File No: 2013/127486  
Our Ref : R/2011/5/1  
Your Ref: MP 11\_0001

**RE: Sydney Heritage Fleet, 5-7 Bank Street, Pyrmont**

The City provides its comments in relation to the proposed new building associated with the Sydney Heritage Fleet that includes small vessel storage, amenities, community-based maritime skills centre, museum display, community space, exhibition pavilion, kiosk and a fixed wharf.

Figure 1: Proposed Bank Street façade.

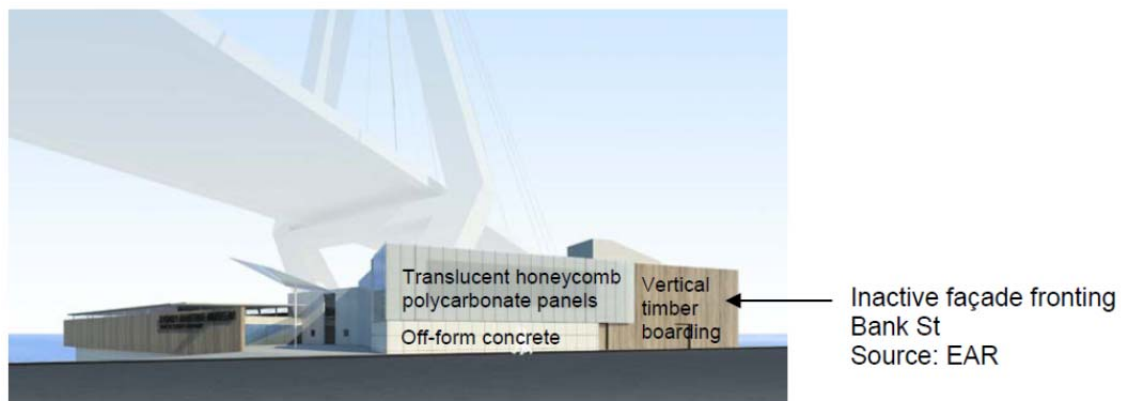
The activities fronting Bank Street are primarily associated with services and utilities such as delivery areas, fire stairwell, lift, store rooms and rubbish bin storage area. Although a degree of façade articulation is achieved through the use of different materials and small projections, the Bank Street elevation is inactive and does not provide opportunities for passive surveillance over the public domain. The blank walls appear like the rear of a development with two doors one of which is a fire escape. The building does not address the street well. Additionally, there is also an inactive façade on the eastern elevation adjacent to the future park. It is recommended that the proposal be amended to improve the activation to the street and park.

Figure 3: Proposed building layout.

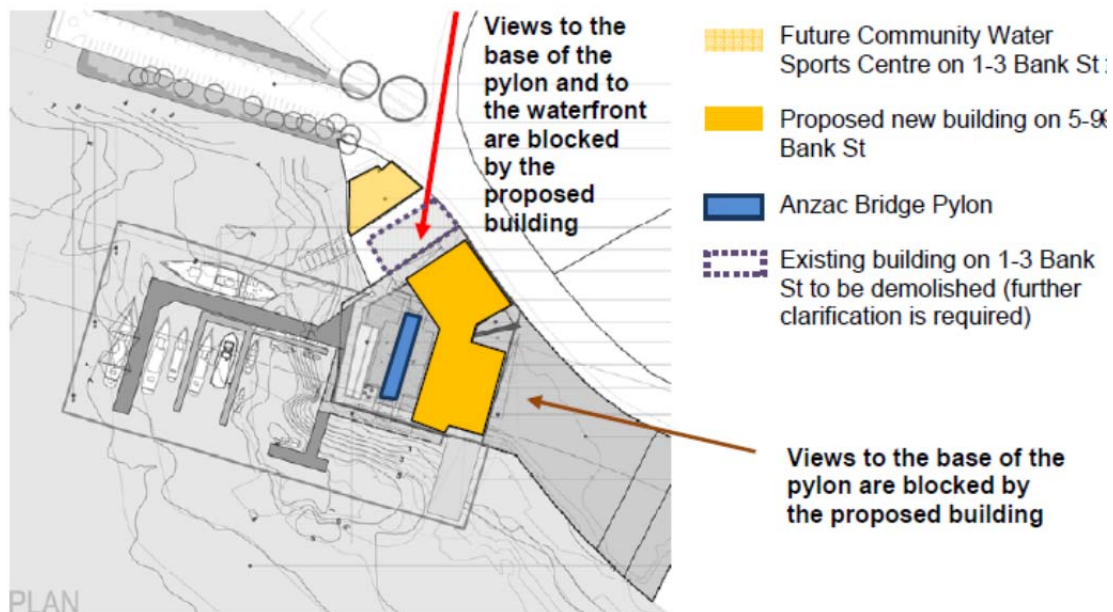
The proposed site planning takes little consideration of the structure of Anzac Bridge and the nearby prominent viewlines. The building wraps around the pylons and blocks views to the base of the structure and to the waterfront.

Figure 4: Site Planning recommendation

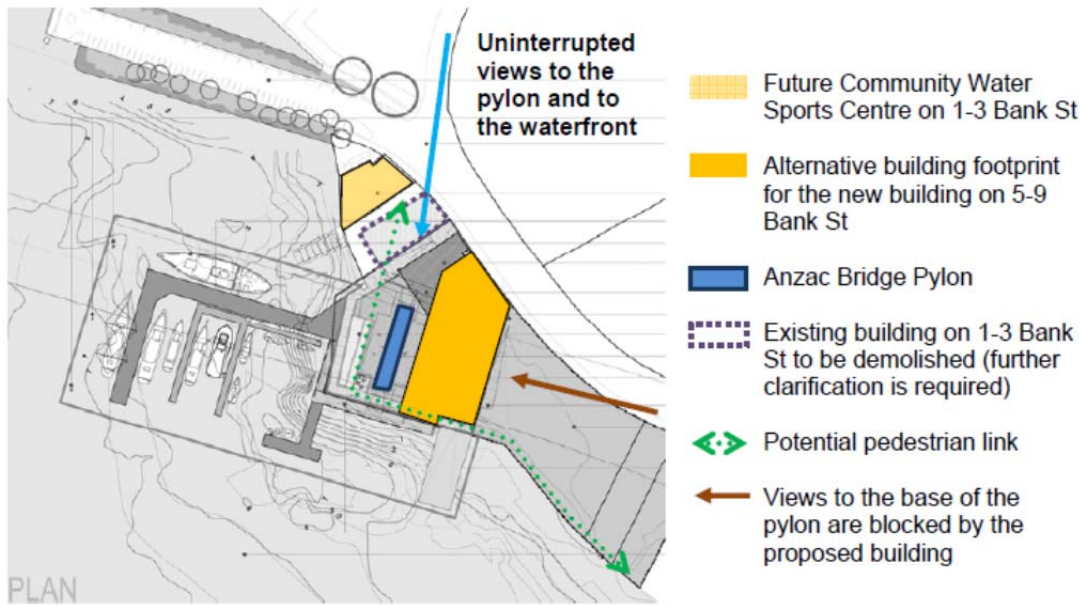
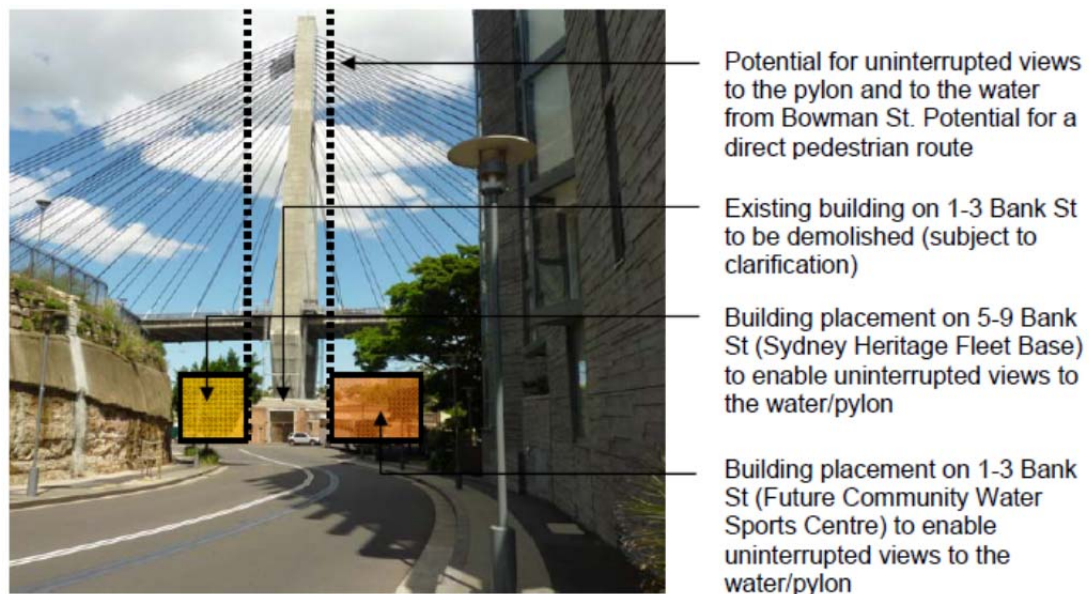
There is an opportunity for the proposal to enhance its relationship with Anzac Bridge and the waterfront, and to improve pedestrian connectivity, by placing the building in a way that enables uninterrupted views from Bowman Street towards the base of the pylon and the water beyond. This design solution could also create a direct pedestrian link from Bowman Street down towards the water. This will be made possible by the future development of the neighbouring site at 1-3 Bank Street for the proposed future community water sports centre.
